# A1152 – WILFORD BRIDGE ROAD, MELTON PROPOSED LOWER SPEED LIMIT

# FORMAL DECISION OF THE PORTFOLIO HOLDER AND THE HEAD OF TRANSPORT POLICY

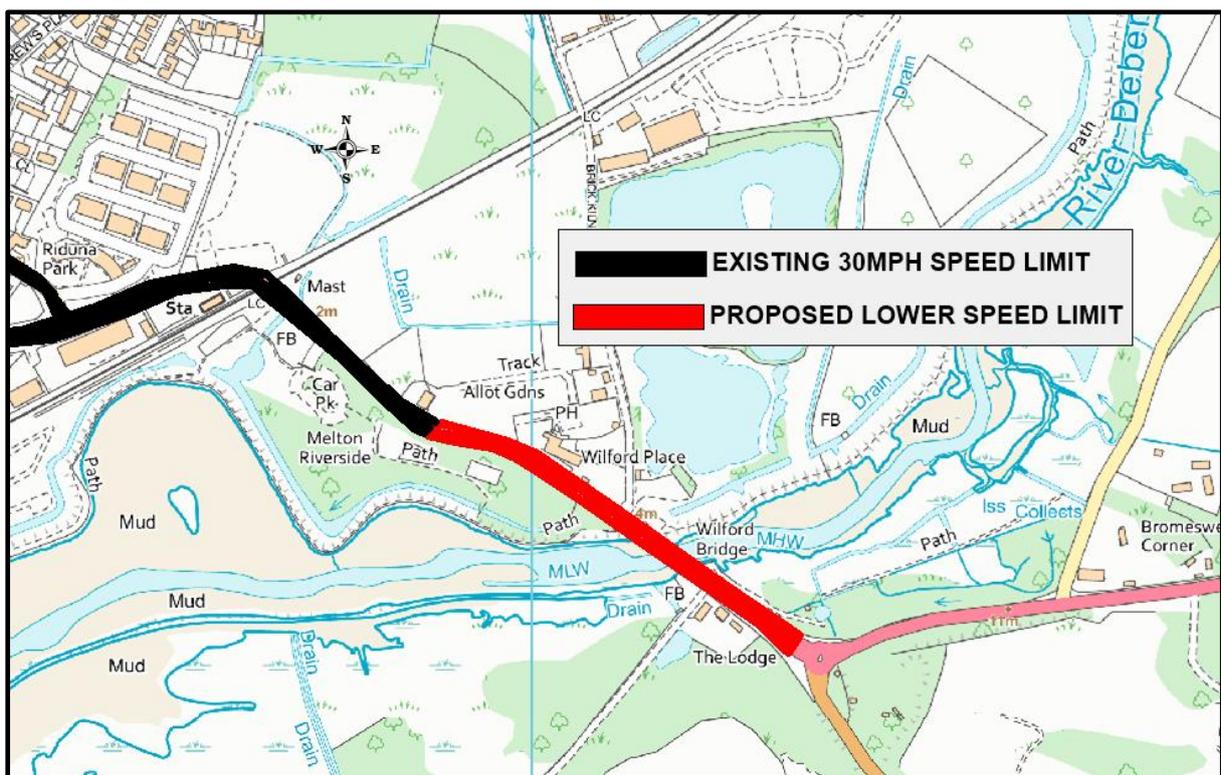
I maintain my support for the introduction of a 30mph limit for the section of highway coloured red in the report.

I have also read the report and agree with Alexander Nicoll that the section of road marked in red should be 30mph providing a consistent limit up to the roundabout.

We share the view of both Cllr Reid and Nicoll that the section marked in red should be 30mph.

That the 30mph speed limit extension is approved for the A1152 Wilford Bridge Road based on Paragraph 21 of the Speed Limit Policy.

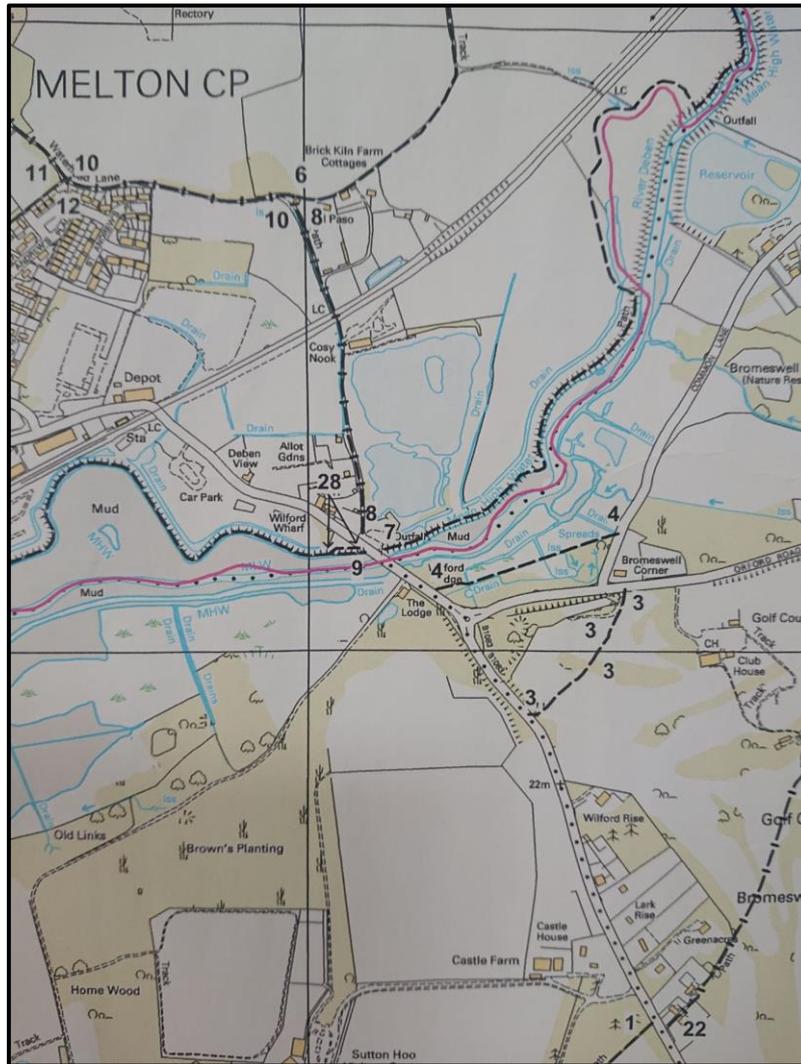
We believe that by reducing the speed limit to 30mph this would help achieve a safer environment for our pedestrians and cyclists as well as for motor vehicles. This stretch of road is an extremely popular route for walkers and cyclists with five footpaths converging at the Wilford Bridge (see map below). Pedestrians often need to cross Wilford Bridge Road to continue their journey. The proposed Coastal Path which will also run along this stretch of Wilford Bridge Road will exacerbate the safety issues associated with walkers. It is also the main walking route to Sutton Hoo from Melton train station, a site of increasing popularity since the movie 'The Dig'. Attempting to walk alongside the road or cross over at the Wilford Bridge whilst vehicles are travelling at 60mph is very hazardous.
